# Access Compliance Report

## Public Rights-of-Way

Intersection ID: 47015	Main Street: TRIBUNE_DR	Cross Street: KRAUS_GLEN_DR	Location: E
ADA ID: EA63A5348045	Ramp Type: BlendTrans1	Initial Pass/Fail: Fail	Overall Compliance: No
		Severity Score: 10

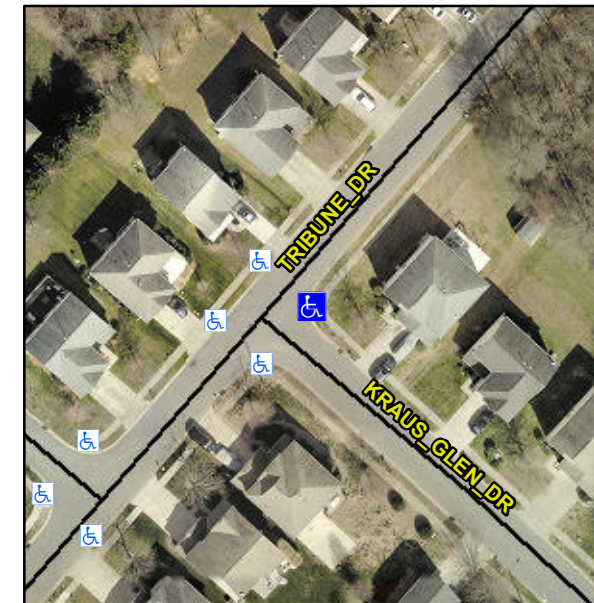
**Not Found, R304.5.1, R304.5.3**

Compliance	Description	Data	Compliance	Description	Data
N/A	Ramp Length (in)	46.0	Yes	BlendTrans Slope (%)	2.0
No	Ramp Width (in)	47.0	No	BlendTrans XSlope (%)	2.6
N/A	Flare Type LT	N/A	N/A	Flare Type RT	N/A
N/A	Flare Slope LT (%)	N/A	N/A	Flare Slope RT (%)	N/A
N/A	Flare Traversable LT?	N/A	N/A	Flare Traversable RT?	N/A
N/A	Landing Length (in)	N/A	N/A	DWS Provided?	N/A
N/A	Landing Width (in)	N/A	N/A	DWS Contrast?	N/A
N/A	Landing Slope (%)	N/A	N/A	DWS Length (in)	N/A
N/A	Landing X Slope (%)	N/A	N/A	DWS Full Width?	N/A
N/A	Landing Curb? (Y/N)	N/A	N/A	DWS Offset (in)	N/A
N/A	Shared Landing?	N/A			
N/A	Gutter Ponding?	N/A	N/A	Gutter Slope (%)	N/A
N/A	Gutter Lip Ht (in)	N/A	N/A	Gutter X Slope (%)	N/A
N/A	Painted X Walk1?	No	N/A	Painted X Walk2?	No
	X Walk 1 Direction	To NW		X Walk 2 Direction	To SW
	X Walk 1 Width (in)	N/A		X Walk 2 Width (in)	N/A
	X Walk 1 Slope (%)	2.4		X Walk 2 Slope (%)	2.1
	X Walk 1 X Slope (%)	2.4		X Walk 2 X Slope (%)	0.7

N/A	Ramp inside XWalk1?	N/A	N/A	Ramp inside XWalk2?	N/A
	Road Slope (%)	1.9		Clear Space?	N/A
	Road X Slope (%)	3.2	N/A	Clear Space to XWalk (in)	N/A
N/A	Any Obstructions?	N/A	N/A	Storm Grate/Utility Hazard?	N/A
	Obstruction Type			Storm Grate/Utility Type	
		N/A			N/A
			Yes	Surface Condition? (G/P)	Good
			No	Curb Slope (%)	6.9

**Remove & Replace Curb Ramp With Two New Directional Ramps or Equivalent.**
